Engineer: P McGill		
Title Squirty: Controller		
Size A	Document Number <Doc>	Rev 1.0.0
Date:	Tuesday, August 17, 2021	Sheet 1 of 1

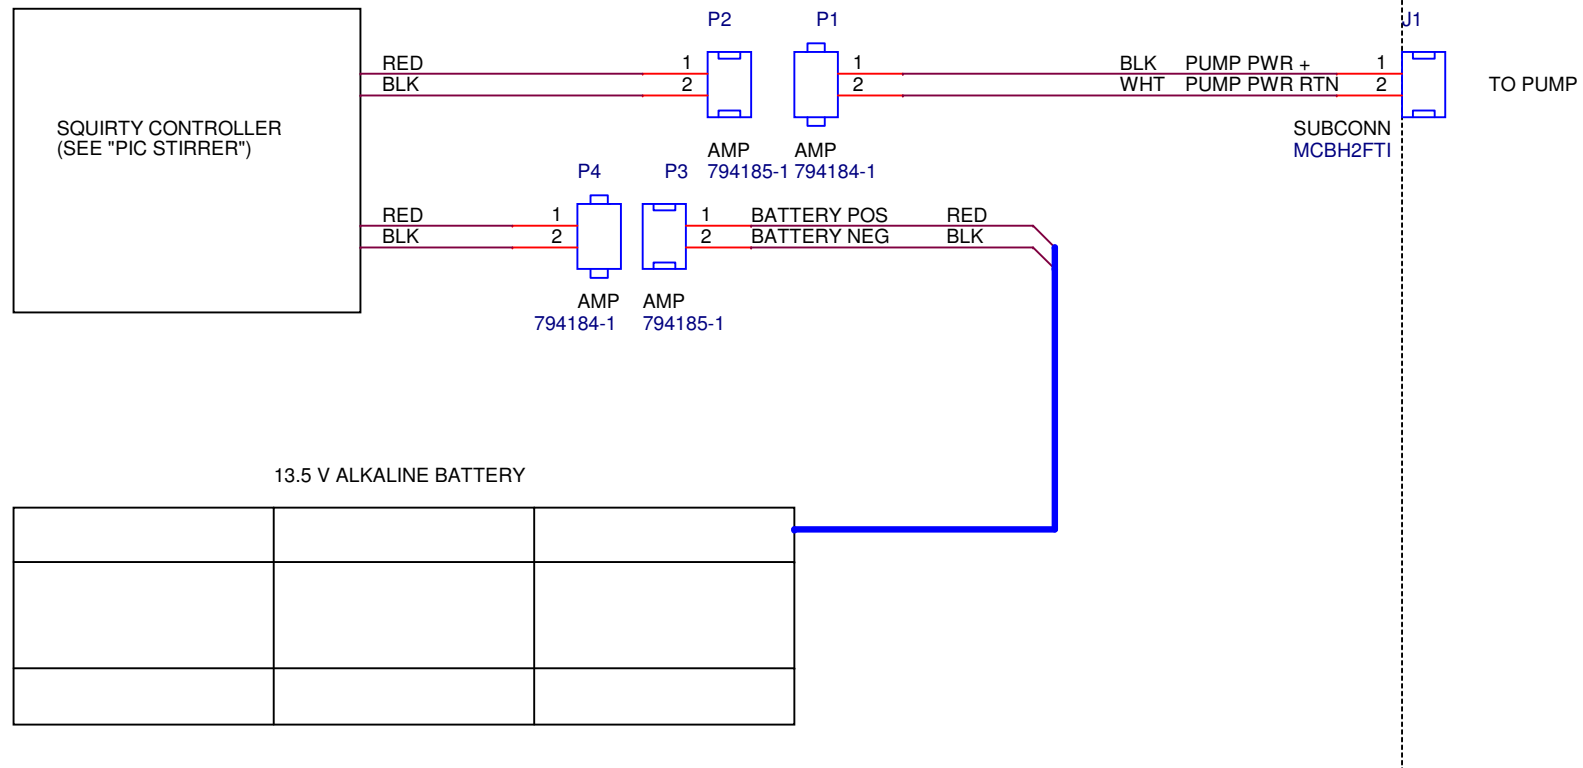
NOTE: PIC STIRRER MODIFIED FOR USE AS SQUIRTY
CONTROLLER BY REPLACING THE FOLLOWING PARTS:

- 1) U1 REPLACE LT1129CST-3.3 WITH LM2936MP-3.3
- 2) U2 REPLACE PIC10F222 WITH PIC10LF322
